# CRMC DECISION WORKSHEET

STATE OF RHODE ISLAND  
**COASTAL RESOURCES MANAGEMENT COUNCIL**  
STAFF REPORT TO THE COUNCIL

Applicant's Name:	William J Ruh Trust
CRMC File Number:	2024-06-087
Project:	Construct a second single-family dwelling with driveway, stormwater, to connect to city utilities on a lot with an existing historic dwelling.
Location:	88 Washington Street; Newport: Plat(s): 12; Lot(s): 46
Water Type/Name:	Narragansett Bay, Type 2
Coastal Feature:	Coastal Headland/Bluff with bulkhead wall
Plans Reviewed:	"CRMC Submission Plan for 88 Washington Street AP 12 Lot 46 in Newport, Rhode Island, Sheets 1 – 4, last revised 12/30/2024, prepared by Thomas J. Principe III PE and stamped CRMC Received 2/13/2025.

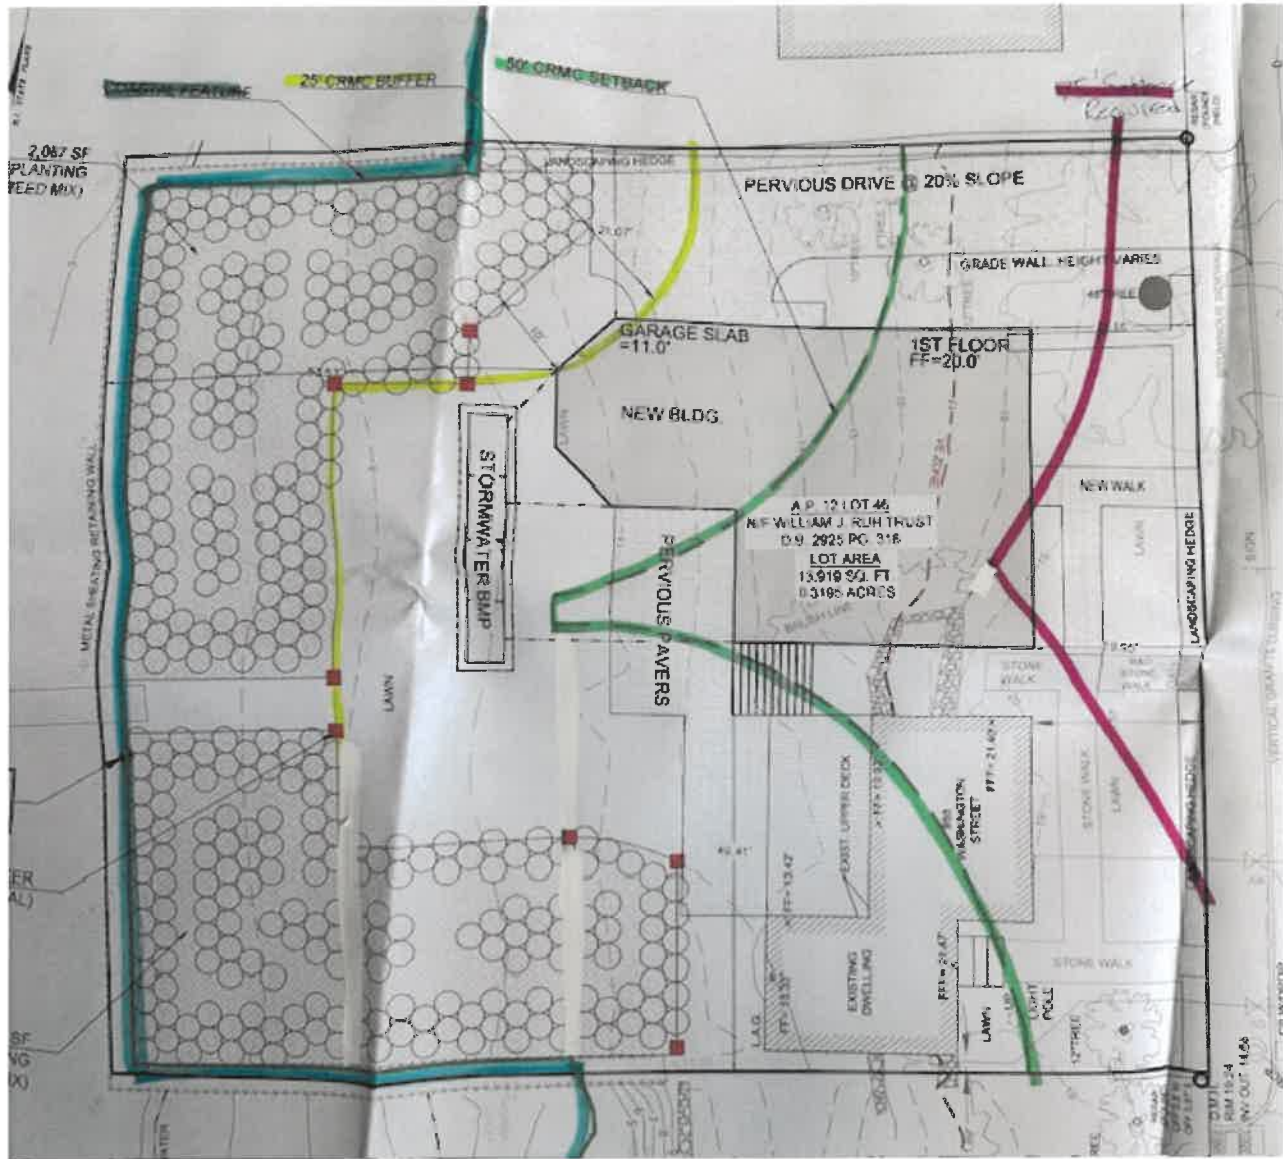
As noted above, the submitted plans depict a 25' Buffer with a 50' Setback. The correct Buffer/Setback have been marked in the image below, where the blue line is the Coastal Feature, the yellow line is the 50% Buffer of 25 feet, the green line doubles as the Setback associated with a 50% Buffer as well as the full Table 4 50 foot Buffer Required, and the purple line is the Buffer derived Setback of 75 feet:

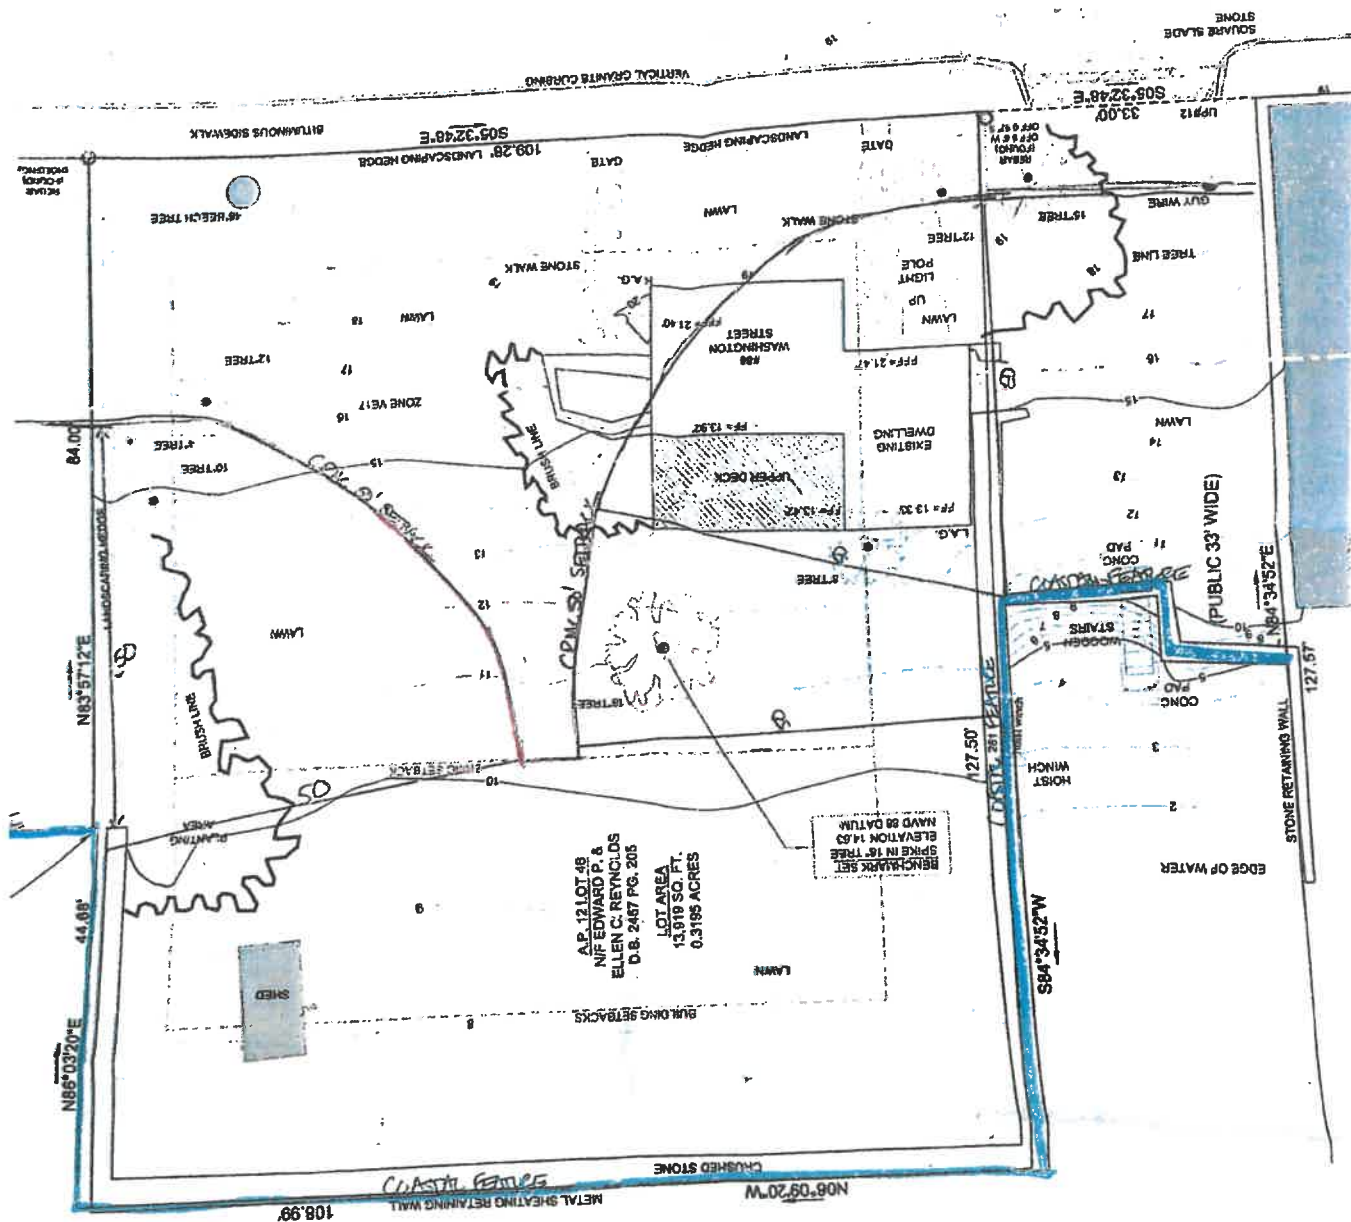
The "CRMC Setback" depicted on the submitted site plans is incorrect. The line shown appears to have been measured only from the most seaward line of the coastal feature. This feature is not a straight line, and extends inland on both the northern and southern property lines – the CRMC measures from the inland edge of the entire Coastal Feature, not just the most seaward portion. (see attached sketch)

No Buffer Zone is depicted on the submitted site plans. As noted above, the Buffer and Setback shall be measured from the entire Coastal Feature, not just the most seaward edge of the Feature.
